Global Cleantech Innovation Programme (GCIP) to accelerate the uptake and investments in innovative cleantech solutions

Review PIF and Make a recommendation

10408

PFD

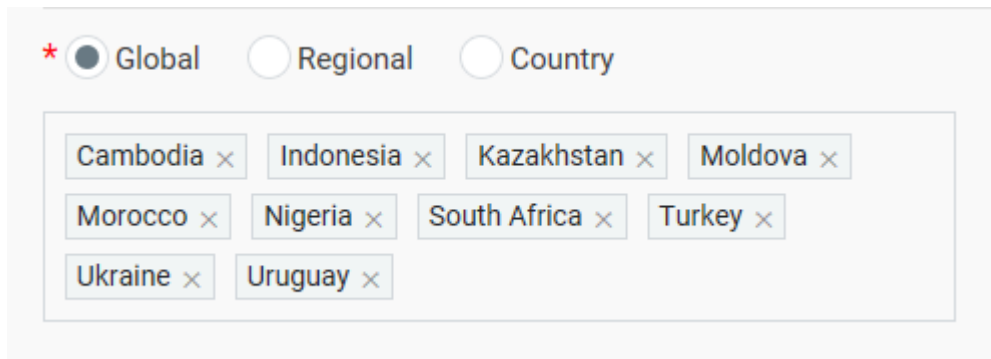
4. There are duplicate countries in the list for Indonesia and Moldova and should be removed. It also misses out listing China and Malaysia which have not submitted their child project concepts yet (as per Annex A in Portal)

Countries
Global, Cambodia, Indonesia, Kazakhstan, Moldova, Morocco, Nigeria,
South Africa, Turkey, Indonesia, Moldova, Tanzania, Thailand, Ukraine,
Uruguay

NOT OK - Ukraine is listed twice.

Compared with the list below (Annex A), in Part I – Countries there are some missing countries: China, Malaysia. Also note that Annex A is largely incomplete: a list of countries is not enough: required elements include: Project Title, Agency, GEF Financing, Agency Fee and Total. NOT OK. Annex A is still incomplete (required elements include: Project Title, Agency, GEF Financing, Agency Fee and Total). In addition, Global Child Project is missing.

Given the above, the number of child projects under the PFD is confusing: Table D has 12 excluding the Global Child Project. However, Annex A only lists 10 missing out on Tanzania, Thailand, Ukraine and Uruguay and Global but at the same time, includes China and Malaysia that the Agency says '*missing will be submitted*'. Please clarify and revise. Please ensure consistency across all the tables and documents included in the submission.

Since project concept data from China and Malaysia are still amiss (not entered in the Portal yet) and given the inconsistencies described above, this PFD in its current form does not give a complete picture of the resources that needs to be accounted for, so we will need to receive a complete resubmission to be able to perform a complete analysis of the financial element of the program.

1. Unfortunately, there seems to be a system error with the list of countries. Below countries are entered in Part I.

The screenshot shows a web form with three radio buttons at the top: 'Global' (selected with a red asterisk), 'Regional', and 'Country'. Below the buttons is a rectangular box containing a list of countries, each in a separate box with a close button (x). The countries listed are: Cambodia, Indonesia, Kazakhstan, Moldova, Morocco, Nigeria, South Africa, Turkey, Ukraine, and Uruguay.

The countries have been reduced to 10 as following : Cambodia, Indonesia, Kazakhstan, Moldova, Morocco, Nigeria, South Africa, Turkey, Ukraine and Uruguay. Furthermore, the following document were uploaded:

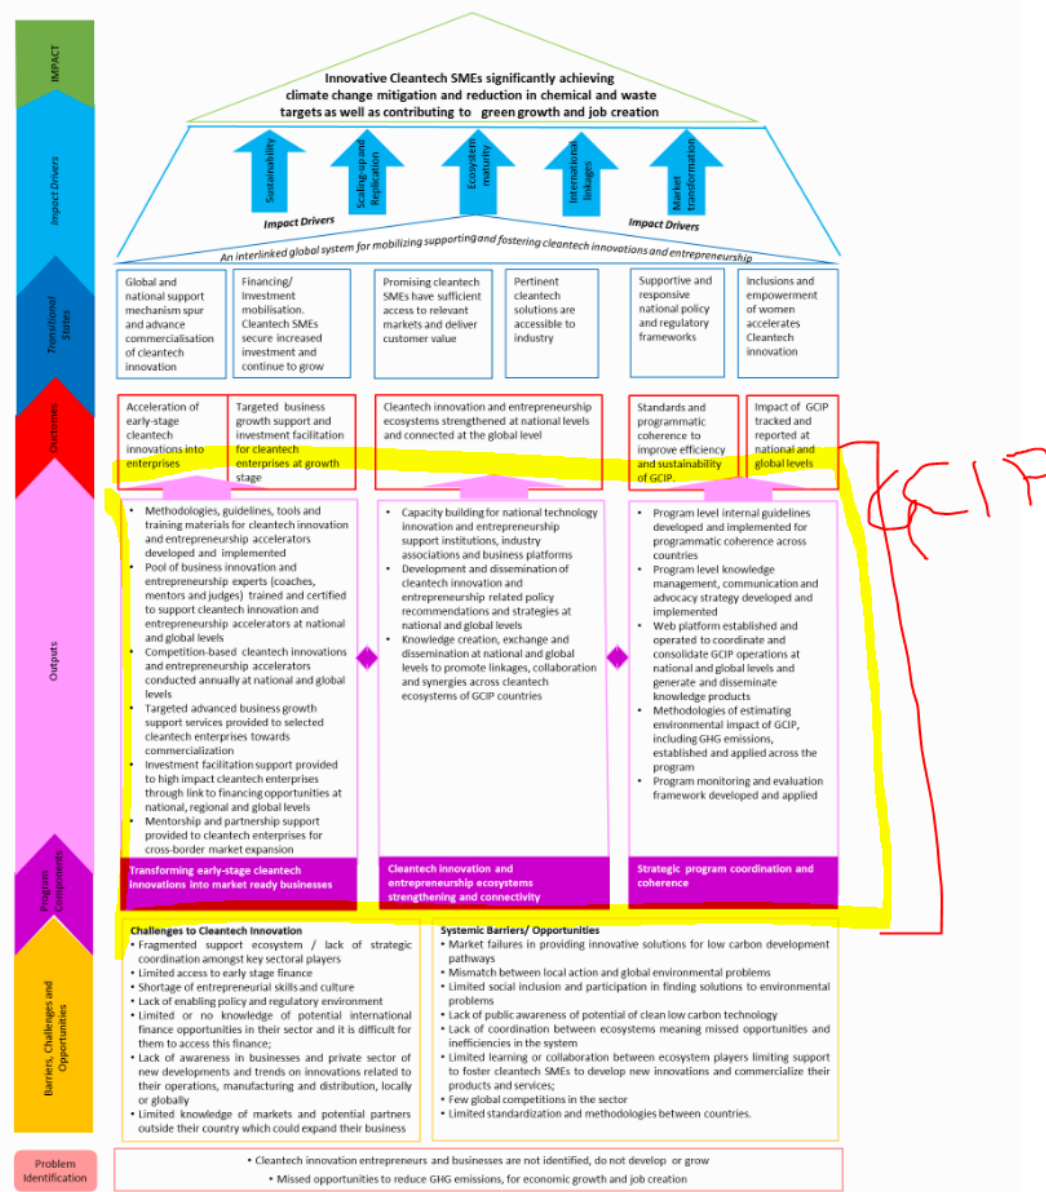
- South Africa: Comment on justification relevant to GCIP-1 has been cleared. However, Core Indicator 10 (uPOPs) is still indicated. Please delete.OK
